SERVICE No. 1002 BULLETIN

Date: June 5, 1997 (M)

**Elevator Down Spring Inspection
/Replacement**

PA-31P, Pressurized Navajo

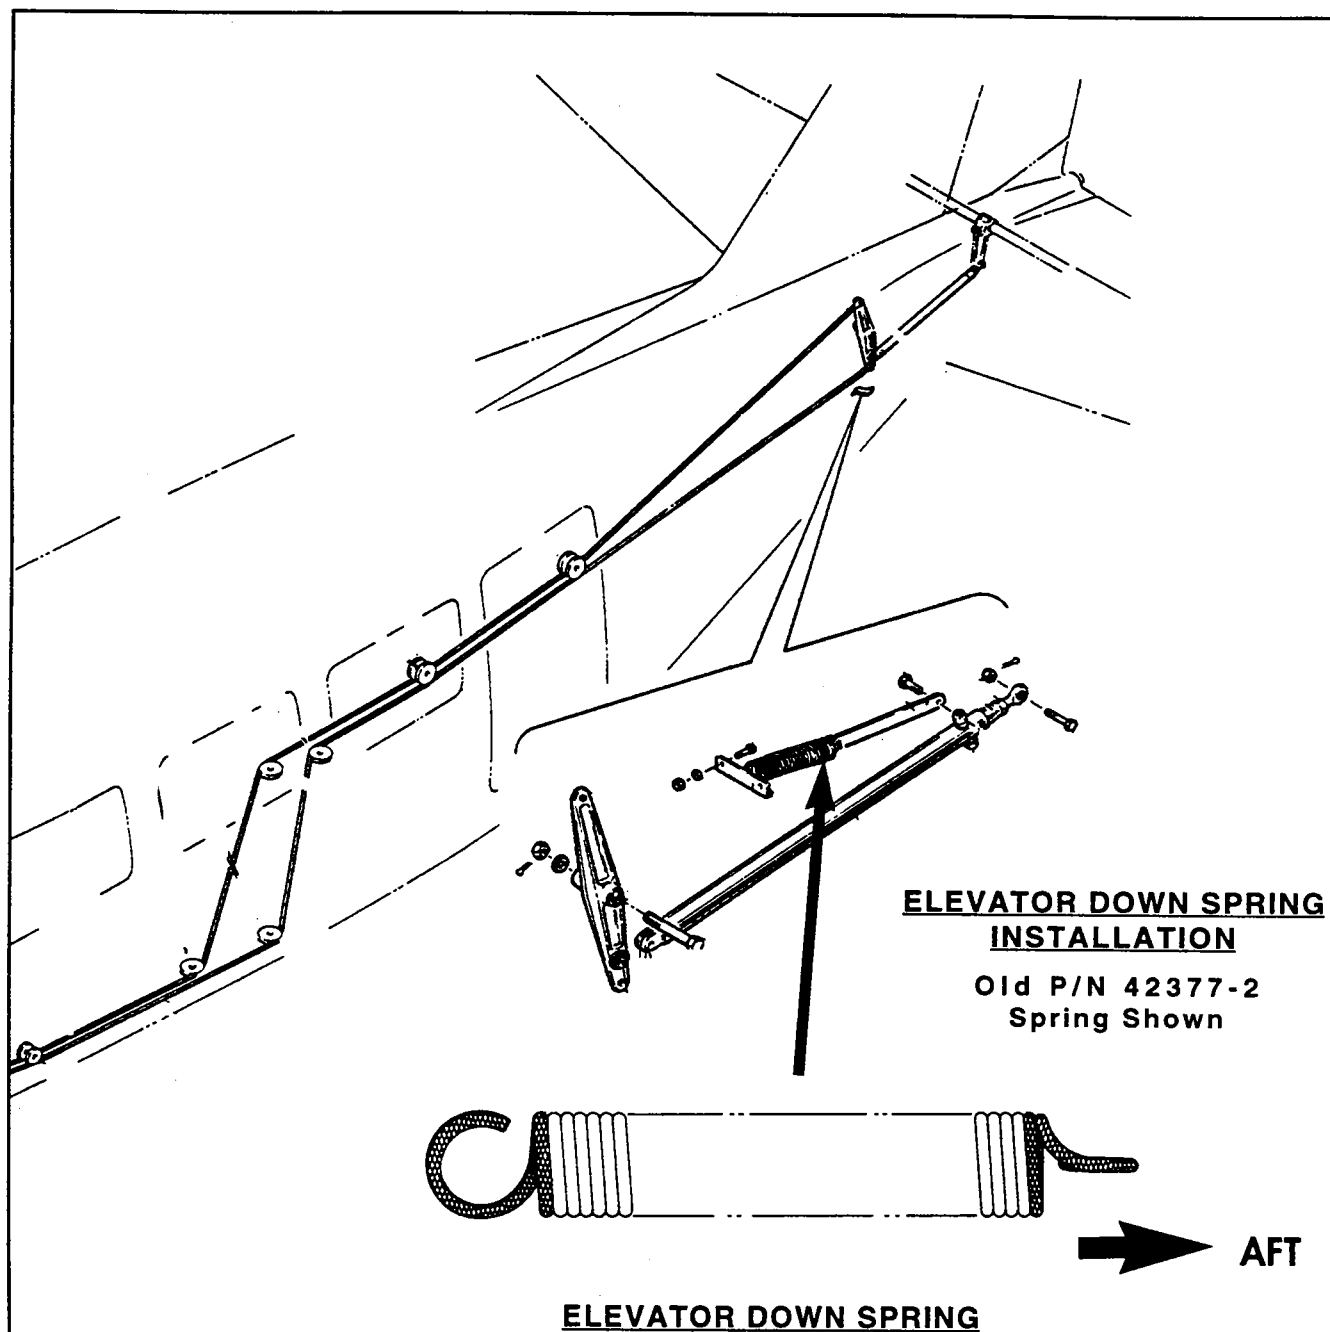
This Service Bulletin requires the replacement of the existing elevator down spring with an improved Elevator Down Spring and a replacement Link and announces a life limit of 1000 hours time in service on current Elevator Down Springs.

1. Remove the bottom half of the tail cone and side access plate(s) from the aft fuselage to gain access to the elevator down spring as necessary. (Also known as a "bungee spring".)
2. Inspect the Elevator Down Spring and Link, if it can be ascertained that Elevator Down Spring, Piper Part Number 71056-03, and Elevator Down Spring Link, Piper Part No. 42376-05 are installed, no further action is required until the accumulation of 1000 hours time in service is reached. If any other part number is installed or if the part numbers installed cannot be identified, replacement must occur per the compliance time above. (See illustration on page 3)
3. If required by the previous instruction, carefully remove the elevator down spring and link.

4. Install a new Elevator Down Spring, Piper Part Number 71056-03, and a Elevator Down Spring Link, Piper Part No. 42376-05. Set proper tension of the elevator balance spring by connecting a scale to the aft end of the spring and pulling rearward until proper tension is obtained with the elevator in the neutral position (PA-31P, $30.0 \pm .05$ lbs.). At this point observe which hole in the link is in line with the hook at the end of the spring and connect the spring into this hole in the link. *Installation of the spring in reverse will damage the spring and link.* (Reference rigging instructions in the appropriate Service Manual.)

The springs and links *must not* remain in service beyond one thousand (1000) hours time in service. When installed, new spring and link must be replaced at each one thousand (1000) hours time in service thereafter.

MATERIAL REQUIRED: If required by inspection or Life Limit, one (1) each, Elevator Down Spring, Piper Part Number 71056-03, and (1) each, Elevator Down Spring Link, Piper Part No. 42376-05, per aircraft.

Effective the date of this Service Bulletin, new Piper P/N 71056-03, elevator down springs will have the P/N painted on the body of the spring to assure positive identification.
